H11017

## DESCRIPTIVE REPORT

# Descriptive Report to Accompany Hydrographic Survey H11017

**Revisions Compiled During Office processing and Certification.**

Figure 3. H11017 Survey Junctions

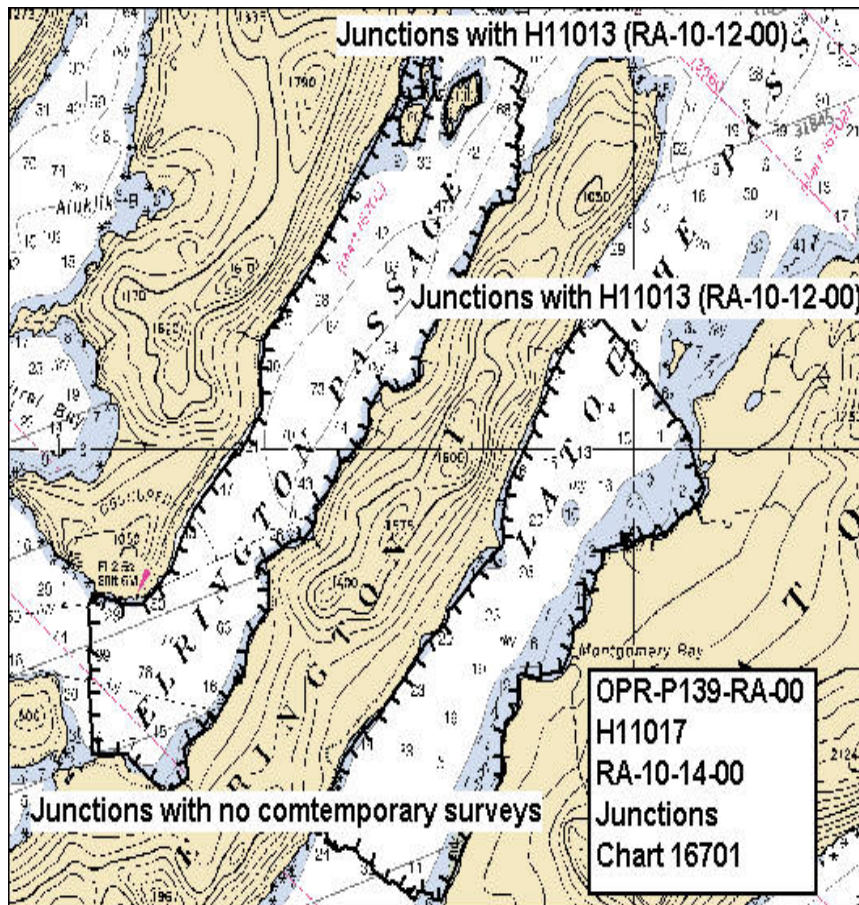
Survey H11017 junctions well with this survey, with differences generally less than two fathoms.<sup>8</sup>

<sup>8</sup> Concur. A comparison of depths with H11013 reflects excellent agreement. Depth differences within the common areas range from 0.5 to 1.0 fathom.

Figure 5. Mid-channel shoaling in Latouche Passage and changes to the 10-fathom curve.

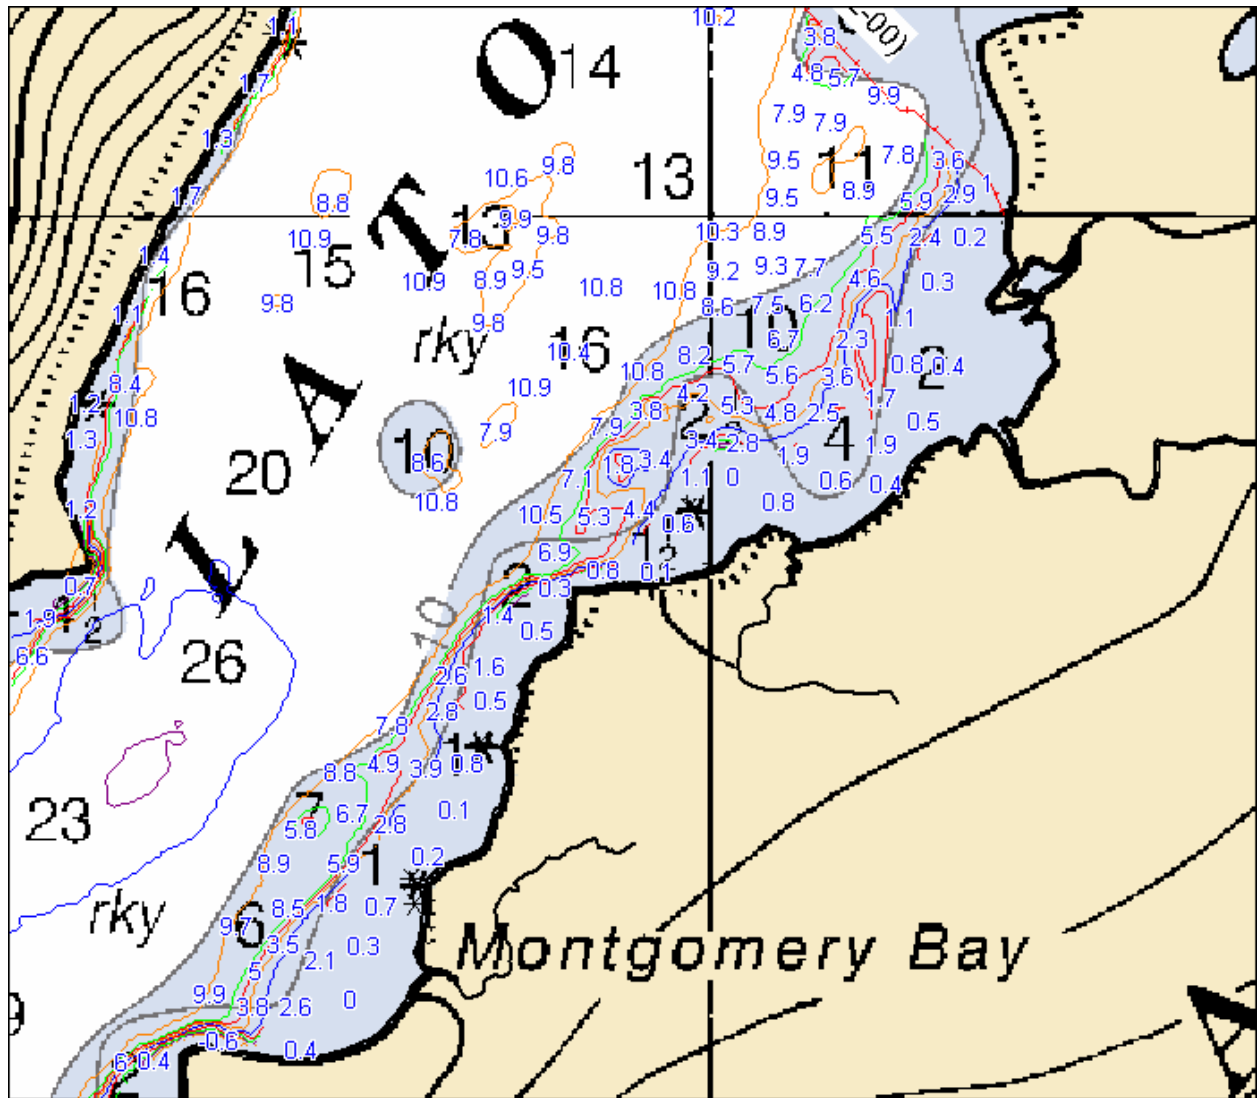
Depths from Survey H11017 were generally 2 to 4 fathoms shoaler than charted depths. Mid-channel shoaling shows some survey depths up to 5 fathoms shoaler than charted depths. Significant shoaling midchannel in Latouche Passage in the vicinity of 60°00'03.512"N, 148°00'38.759"W (443,624.9 E, 6,651,950.5 N) was also observed (see Figures 5 and 6). There is also region on the southeastern shore of Latouche Passage near Montgomery Bay where the surveyed 10-meter<sup>27</sup> curve was found to be

approximately 80 meters inshore of the charted 10-fathom curve. This area extends approximately 0.9<sup>28</sup> nautical miles south from 59°58'51.68"N, 148°01'31.19"W (442778.2E, 6649741.0N) to 59°58'08.0"N 148°02'27.89"W (442819.4 E, 6649780.0 N); see Figure 7. This area was covered with 100% SWMB.

- <sup>26</sup> Concur with hydrographer's statements.
- <sup>27</sup> Strikethrough ~~meter~~ and replace with fathom
- <sup>28</sup> Strikethrough ~~0.9~~ and replace with 0.8

Figure 6. Shoal areas in Latouche Passage.

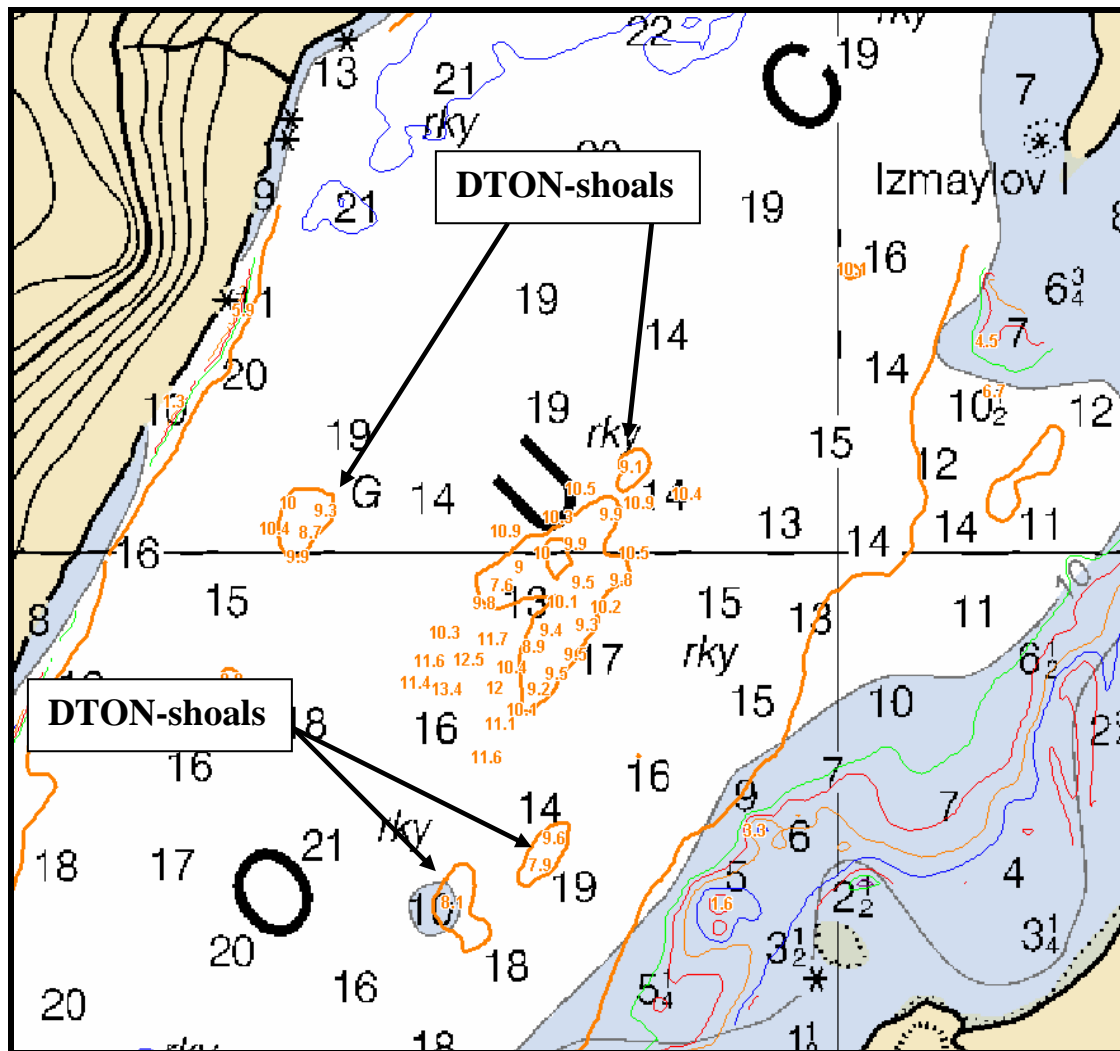
In the vicinity of a charted 9-fathom sounding, the present survey revealed a depth of 12.3<sup>31</sup> fathoms at 59° 59' 20.510"N, 148° 00' 50.514"W (443,422.4 E, 6,650,623.1 N). In this area the surveyed 10-fathom curve was positioned 80 meters inshore of the charted 10-fathom curve. This area was covered by 100% SWMB.<sup>32</sup>

In the vicinity of a charted 14-fathom sounding, the present survey revealed a depth of 7.8<sup>35</sup> fathoms at 59° 59' 09.119"N, 148° 02' 20.113"W (442,028.3 E, 6,650,292.3 N). This area was steep and close to shore. The surveyed 10-fathom curve in this area was positioned 120 meters offshore from the charted 10-fathom curve. This area was covered by 100% SWMB.<sup>36</sup>

- <sup>29</sup> Strikethrough ~~four to five~~ and replace with two to three
- <sup>30</sup> Concur
- <sup>31</sup> Strikethrough ~~12.3~~ and replace with 12.7

- <sup>32</sup> Concur
- <sup>33</sup> Concur
- <sup>34</sup> Concur
- <sup>35</sup> Strikethrough ~~7.8~~ and replace with 7
- <sup>36</sup> Concur
- <sup>37</sup> Strikethrough ~~0.9 to 8.3~~ and replace with 0.8 to 4.5

Figure 7. Surveyed 10-fathom curve compared with Chart 16702

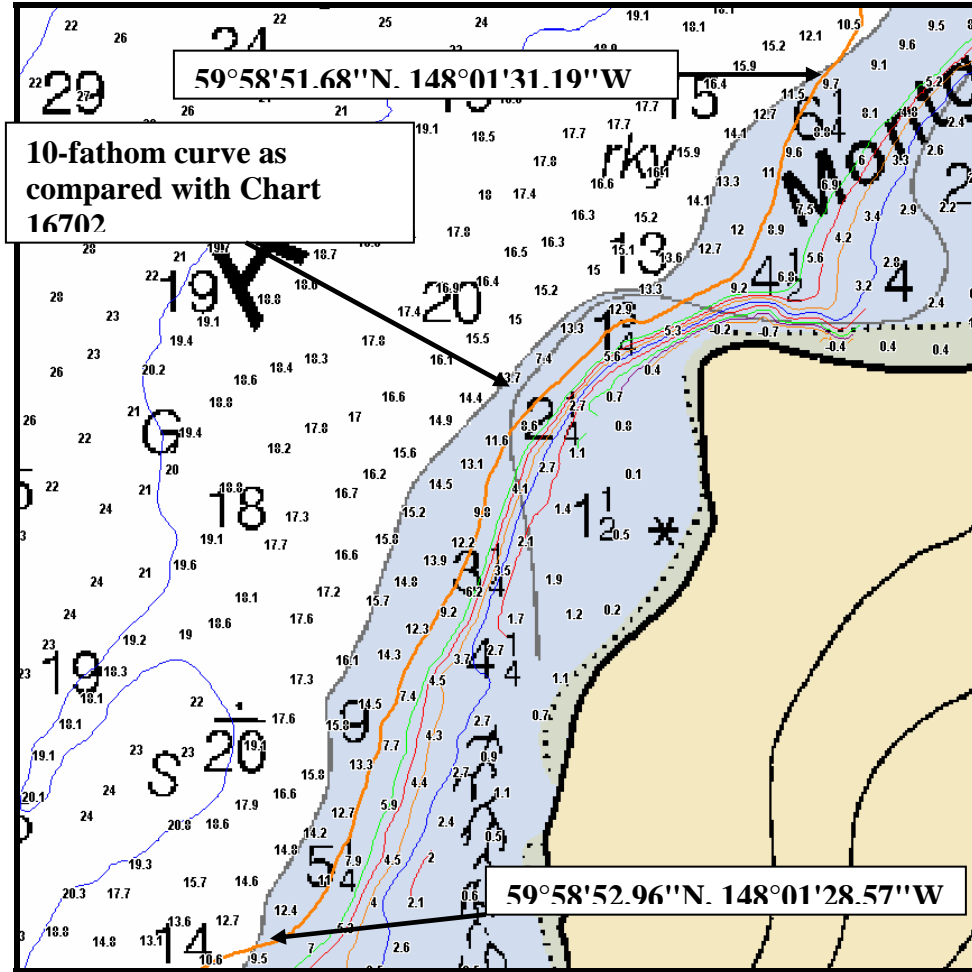
In the vicinity of a charted 14-fathom sounding, the present survey revealed a depth of 7.9<sup>41</sup> fathoms at 60° 00' 38.818"N, 148° 00' 55.837"W (443,377.1 E, 6,653,046.7 N). This area was steep and close to shore and covered by 100% SWMB.<sup>42</sup>

- <sup>38</sup> Concur
- <sup>39</sup> This is the charted depth before the DTONs were applied to the chart.
- <sup>40</sup> Concur
- <sup>41</sup> Strikethrough ~~7.9~~ and replace with 7.8

Figure 8: Replace deep soundings inshore of the limit of hydrography with blue tint

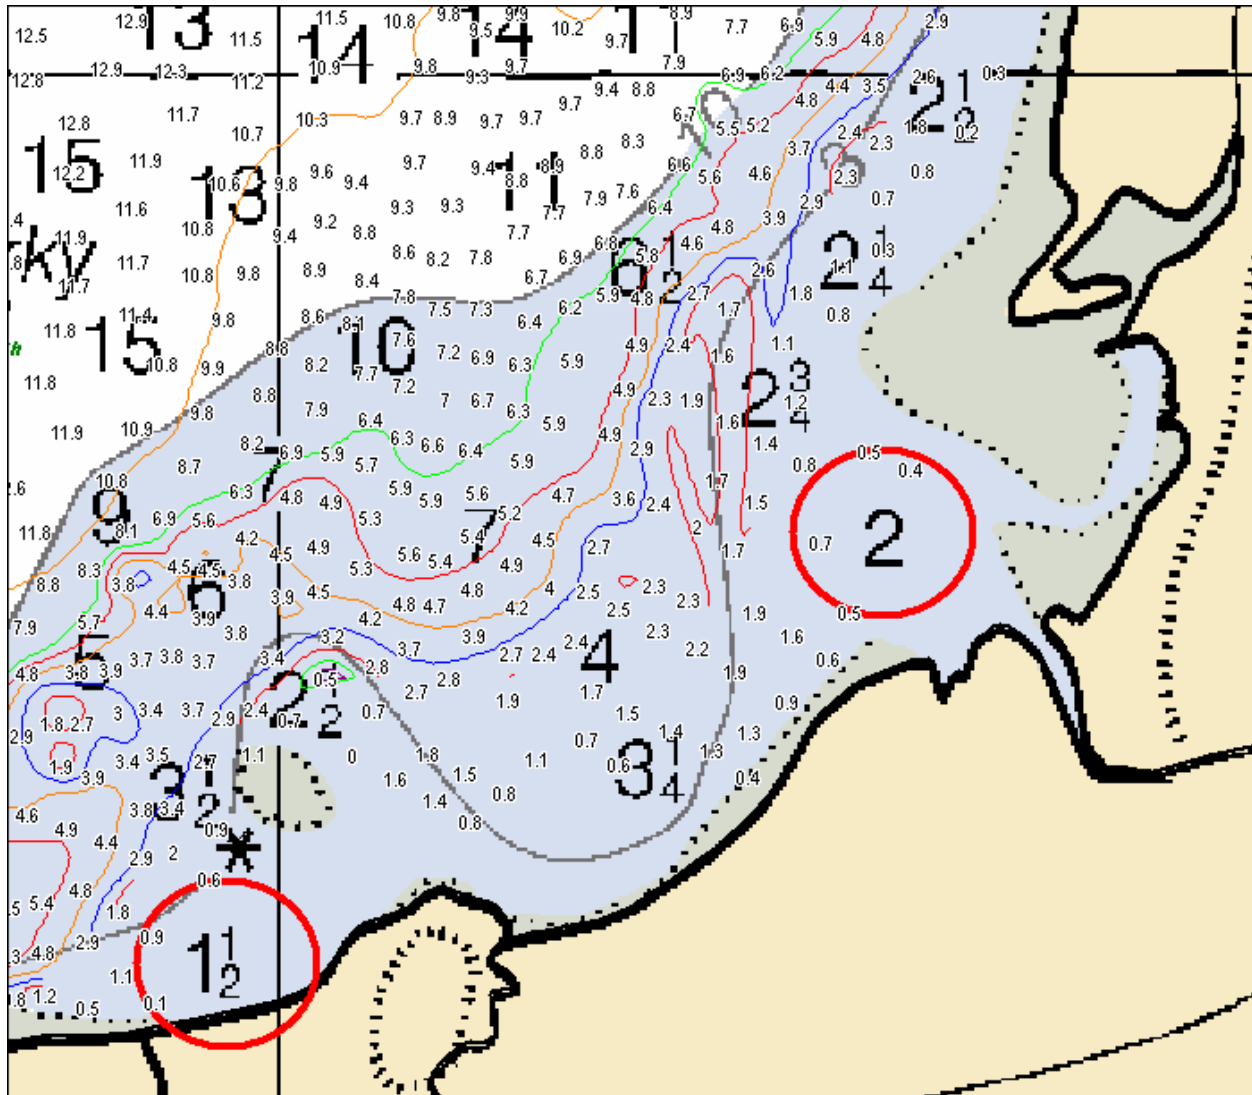
The Hydrographer recommends the final sounding plot supercede charts 16701 and 16702 as noted.<sup>44</sup> In several areas, charted soundings inshore of the limit of hydrography were deeper than soundings collected offshore at the limit of hydrography. The Hydrographer recommends removing these charted soundings,<sup>45</sup> when inshore and deeper than soundings recorded at the limits of hydrography, and replacing with blue tint on the chart to depict the areas as non-navigable (refer to Figure 8 for an example).<sup>46</sup>

- <sup>42</sup> Concur
- <sup>43</sup> Concur
- <sup>44</sup> Concur
- <sup>45</sup> Concur
- <sup>46</sup> Do not concur. Tint area is not based on survey limits and is already determined by MCD.
